Access Compliance Report

Public Rights-of-Way

(Curb Ramps)

Intersection ID: 4106	Main Street: CLAYBROOKE_DR	Cross Street: TURNING_LEAF_CT	Location: SE
ADA ID: 72938918859C	Ramp Type: Perp	Initial Pass/Fail: Fail	Overall Compliance: No
Severity Score: 21.25			
Codes/Mitigation Info/Possible Solution		Field Measurements/Component Compliance

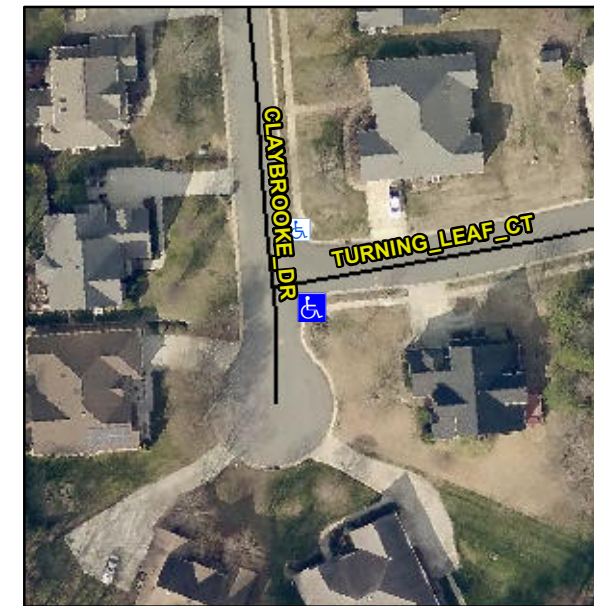
Not Found, R304.5.1, R304.5.3

Compliance	Description	Data	Compliance	Description	Data
N/A	Ramp Length (in)	91.0	Yes	Ramp Slope (%)	5.3
No	Ramp Width (in)	38.0	No	Ramp XSlope (%)	6.2
N/A	Flare Type LT	N/A	N/A	Flare Type RT	N/A
N/A	Flare Slope LT (%)	N/A	N/A	Flare Slope RT (%)	N/A
N/A	Flare Traversable LT?	N/A	N/A	Flare Traversable RT?	N/A
N/A	Landing Length (in)	N/A	N/A	DWS Provided?	N/A
N/A	Landing Width (in)	N/A	N/A	DWS Contrast?	N/A
N/A	Landing Slope (%)	N/A	N/A	DWS Length (in)	N/A
N/A	Landing X Slope (%)	N/A	N/A	DWS Full Width?	N/A
N/A	Landing Curb? (Y/N)	N/A	N/A	DWS Offset (in)	N/A
N/A	Shared Landing?	N/A			
N/A	Gutter Ponding?	N/A	N/A	Gutter Slope (%)	N/A
N/A	Gutter Lip Ht (in)	N/A	N/A	Gutter X Slope (%)	N/A
N/A	Painted X Walk1?	No	N/A	Painted X Walk2?	N/A
	X Walk 1 Direction	To N		X Walk 2 Direction	N/A
N/A	X Walk 1 Width (in)	N/A	N/A	X Walk 2 Width (in)	N/A
	X Walk 1 Slope (%)	1.3		X Walk 2 Slope (%)	N/A
	X Walk 1 X Slope (%)	7.8		X Walk 2 X Slope (%)	N/A

Remove & Replace Entire Ramp.
